**CITY OF MENASHA
PLAN COMMISSION
Menasha City Center
100 Main Street, Menasha
Rooms 132 and 133**

**December 7, 2021
3:30 PM**

AGENDA

To: Plan Commission
From: Community Development Department/SS
Date: December 7, 2021
Re: **Special Use Permit and Site Plan Review – TriCity Auto – 1415 Appleton Road (Parcel 6-01651-00)**

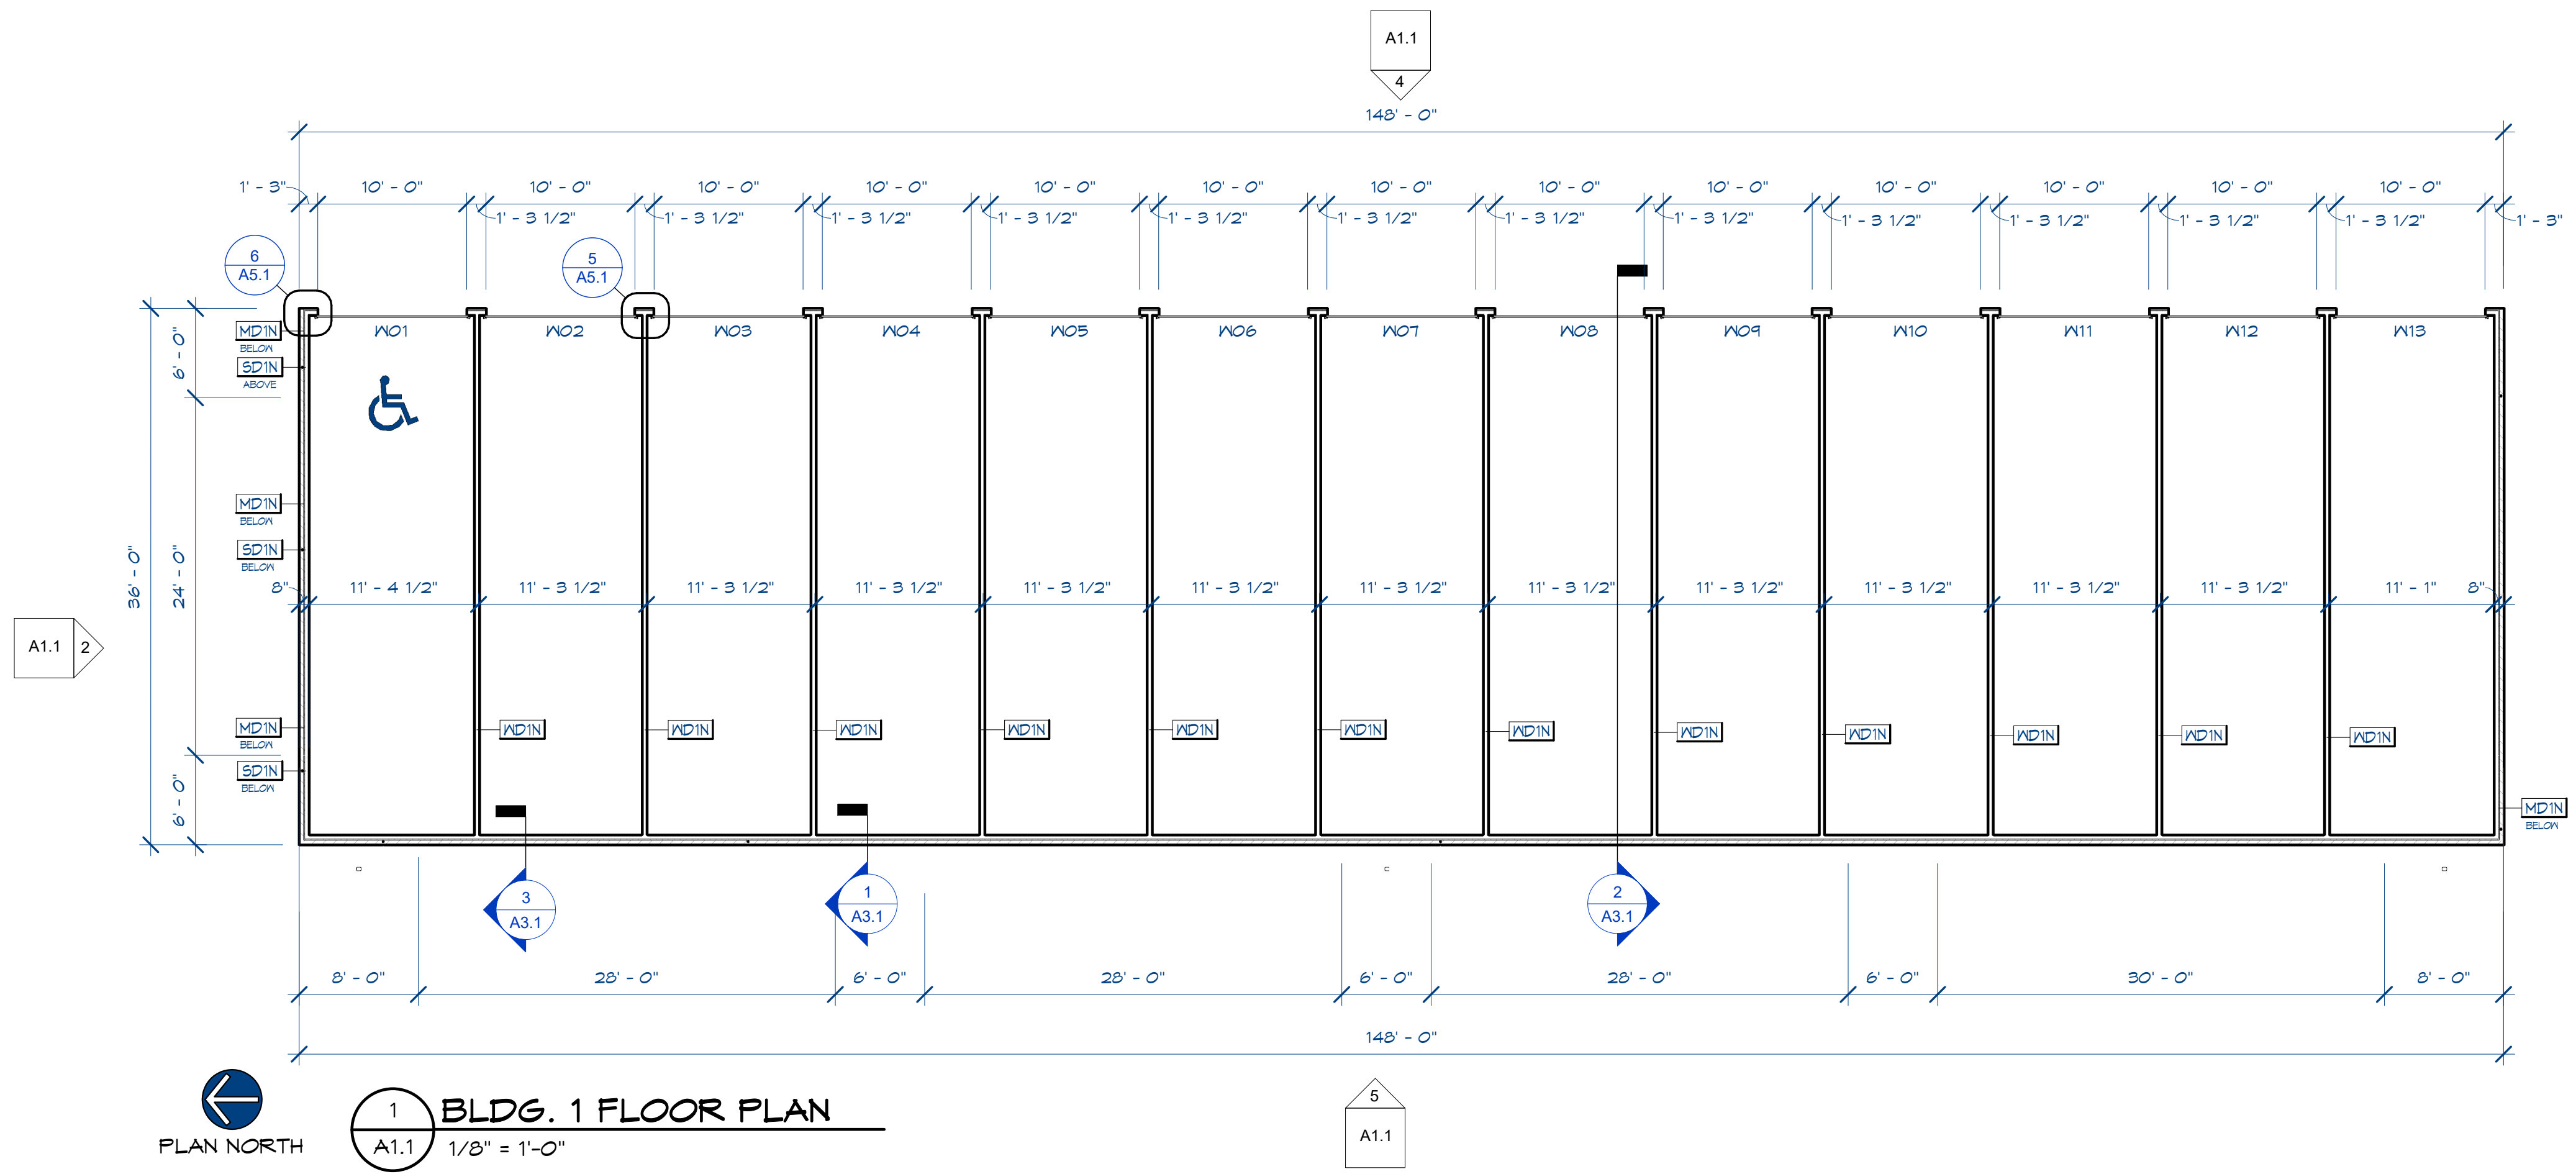
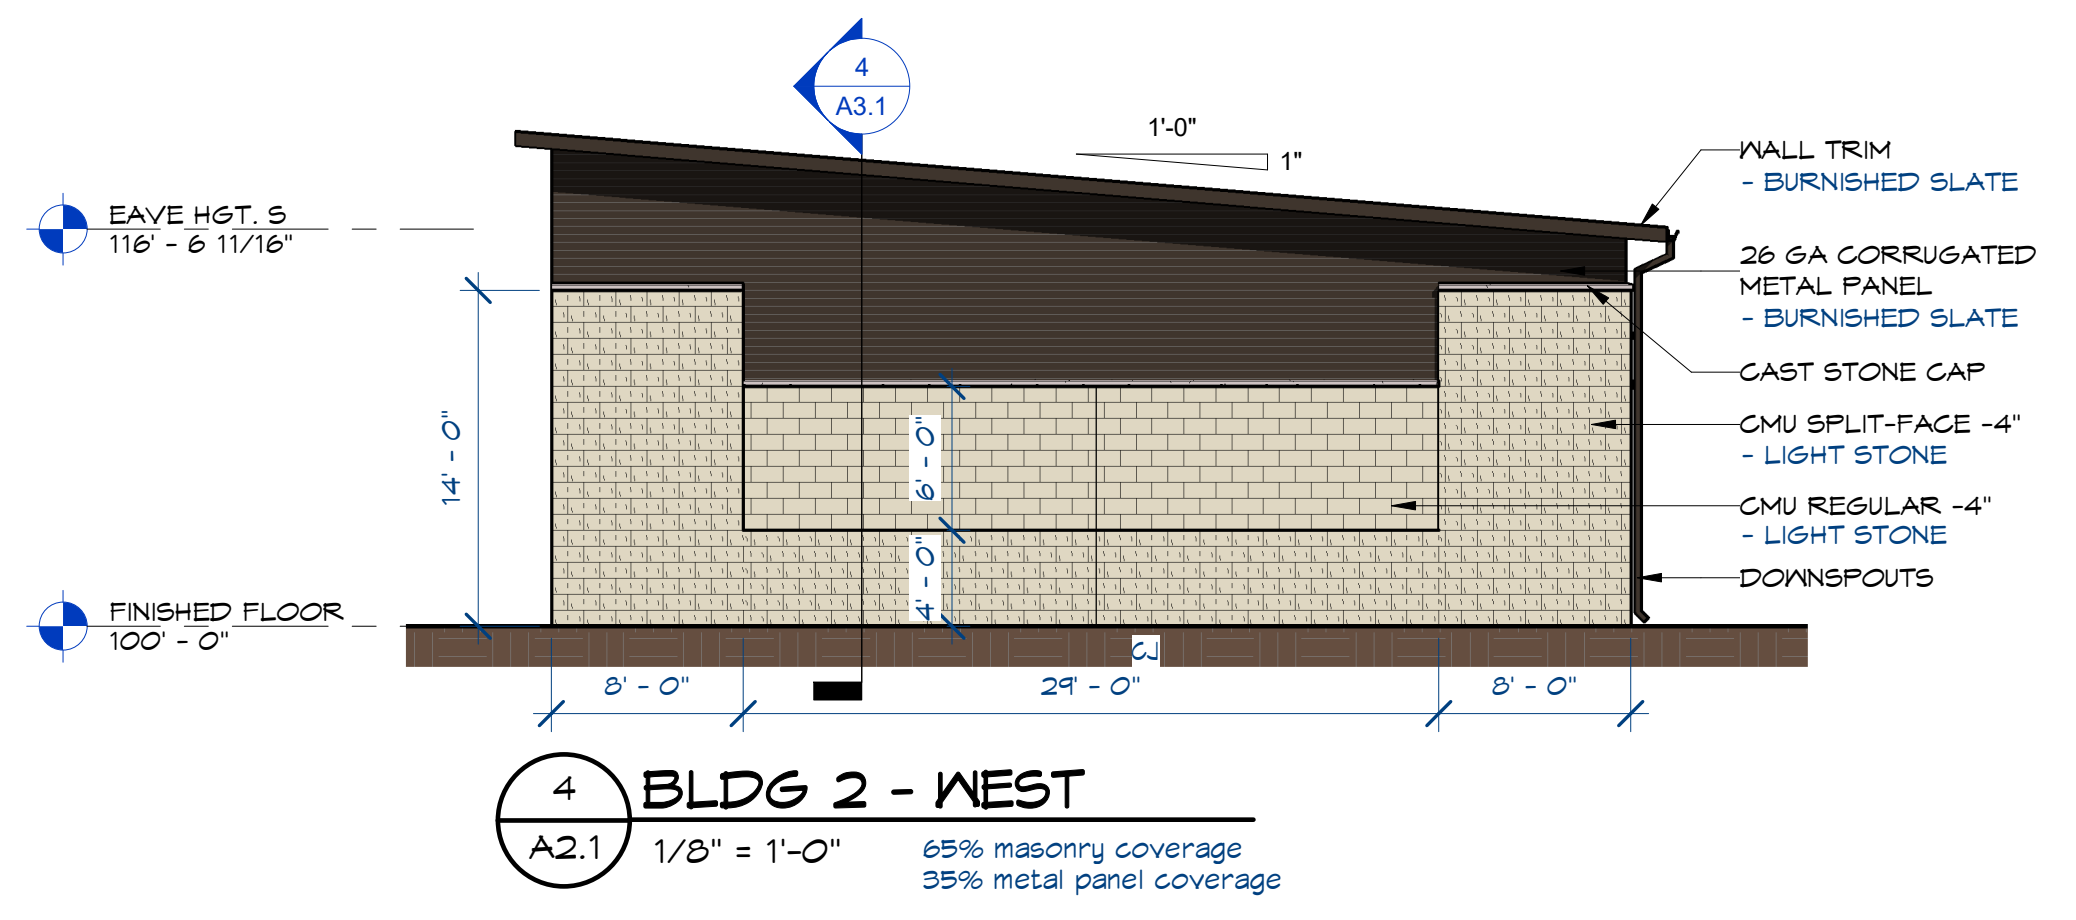
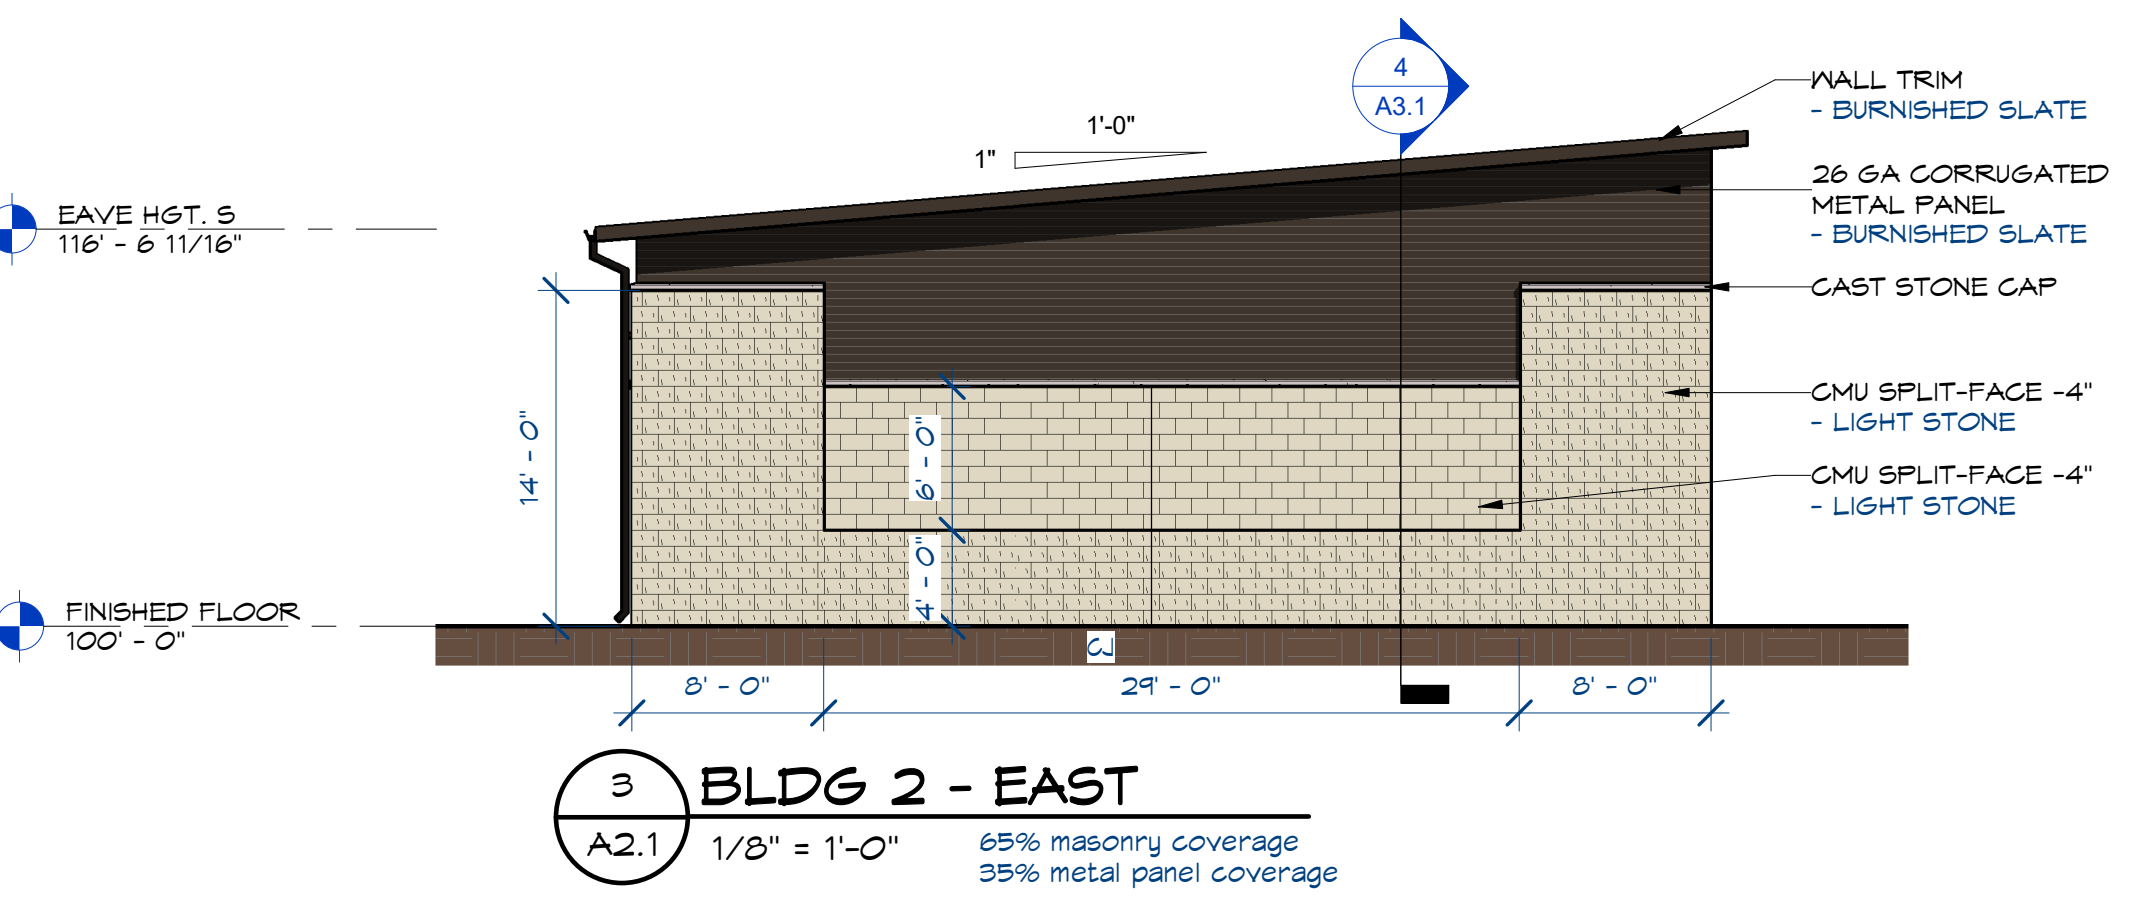
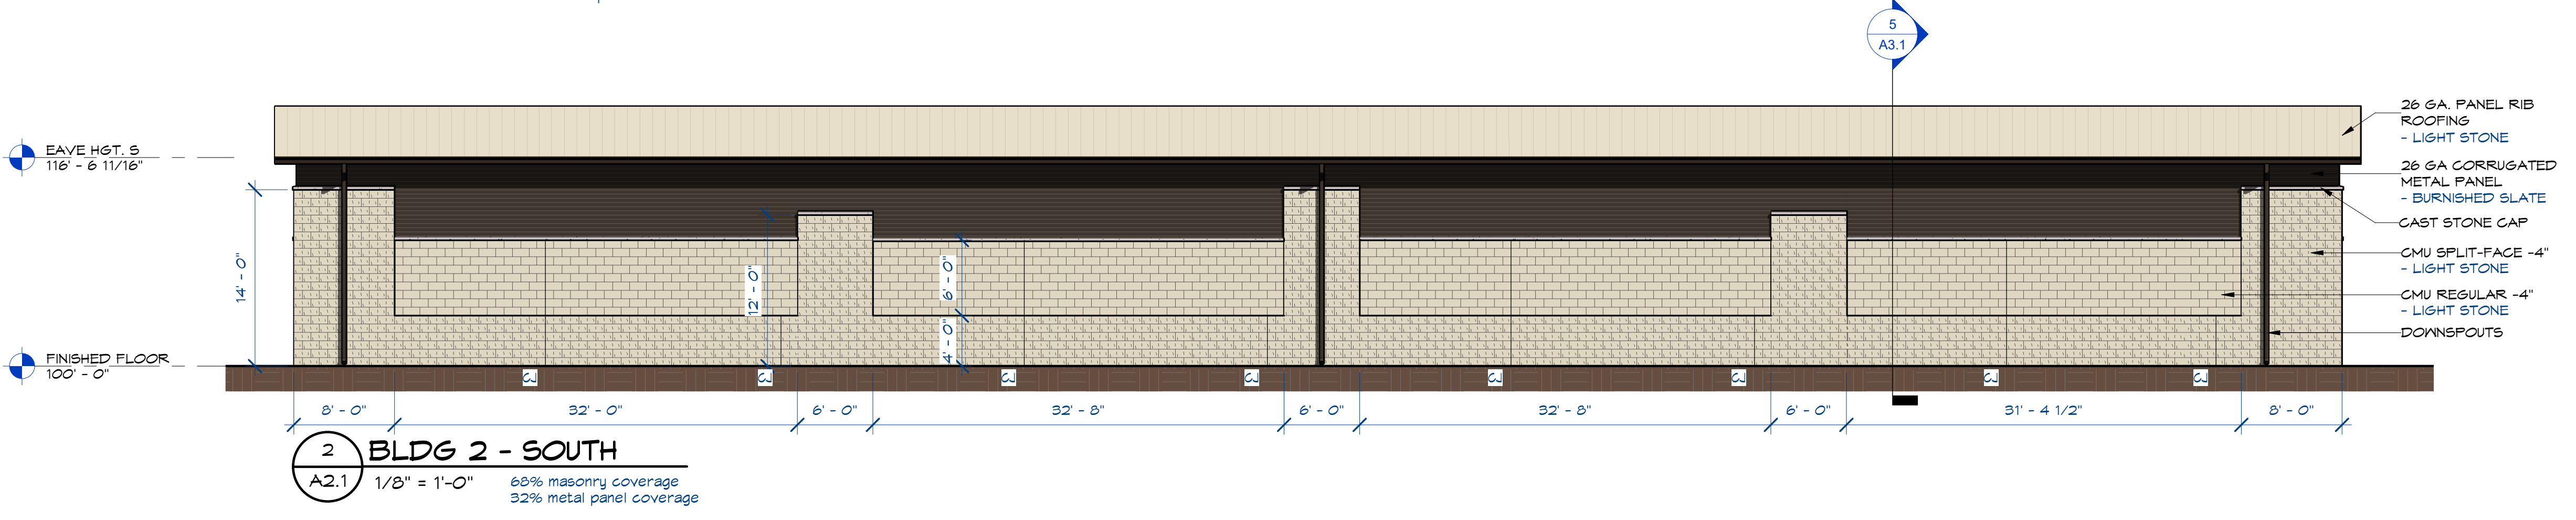
The façade meets the 50% masonry requirement with roughly 65% of the building being masonry block. The remainder of the façade along the roof line is a metal wall panel; however this is over the 25% allowed. The façade will need to be revised to meet requirements outlined in Sec. 13-1-12(f).
